# Access Compliance Report

## Public Rights-of-Way

### (Curb Ramps)

Intersection ID: 12826	Main Street: E_5TH_ST	Cross Street: N_ALEXANDER_ST	Location: N
ADA ID: 6F953DF4595D	Ramp Type: PerpDiag	Initial Pass/Fail: Fail	Overall Compliance: No
			Severity Score: 48.75

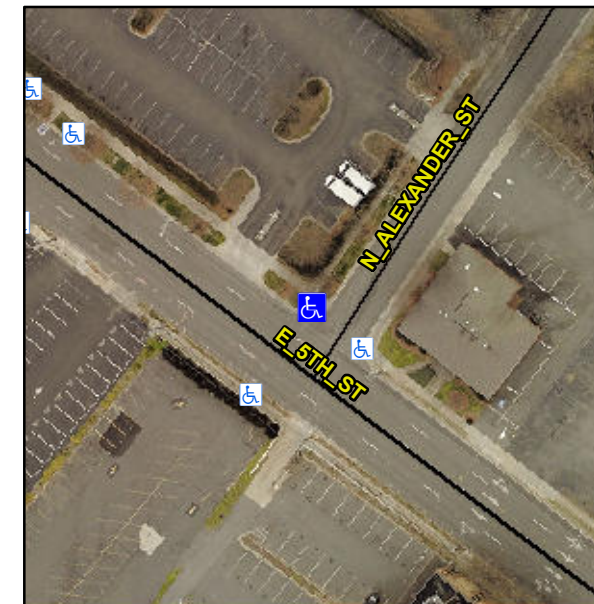
**R304.5.1, R304.2.2, R304.5.3**

Compliance	Description	Data	Compliance	Description	Data
N/A	Ramp Length (in)	60.0	No	Ramp Slope (%)	9.0
No	Ramp Width (in)	28.0	No	Ramp XSlope (%)	3.1
N/A	Flare Type LT	N/A	N/A	Flare Type RT	N/A
N/A	Flare Slope LT (%)	N/A	N/A	Flare Slope RT (%)	N/A
N/A	Flare Traversable LT?	N/A	N/A	Flare Traversable RT?	N/A
N/A	Landing Length (in)	N/A	N/A	DWS Provided?	N/A
N/A	Landing Width (in)	N/A	N/A	DWS Contrast?	N/A
N/A	Landing Slope (%)	N/A	N/A	DWS Length (in)	N/A
N/A	Landing X Slope (%)	N/A	N/A	DWS Full Width?	N/A
N/A	Landing Curb? (Y/N)	N/A	N/A	DWS Offset (in)	N/A
N/A	Shared Landing?	N/A			
N/A	Gutter Ponding?	N/A	N/A	Gutter Slope (%)	N/A
N/A	Gutter Lip Ht (in)	N/A	N/A	Gutter X Slope (%)	N/A
N/A	Painted X Walk1?	No	N/A	Painted X Walk2?	No
	X Walk 1 Direction	To SW		X Walk 2 Direction	To SE
N/A	X Walk 1 Width (in)	N/A	N/A	X Walk 2 Width (in)	N/A
	X Walk 1 Slope (%)	4.5		X Walk 2 Slope (%)	1.3
	X Walk 1 X Slope (%)	1.6		X Walk 2 X Slope (%)	0.7

**Remove & Replace Curb Ramp With Two New Directional Ramps or Equivalent.**
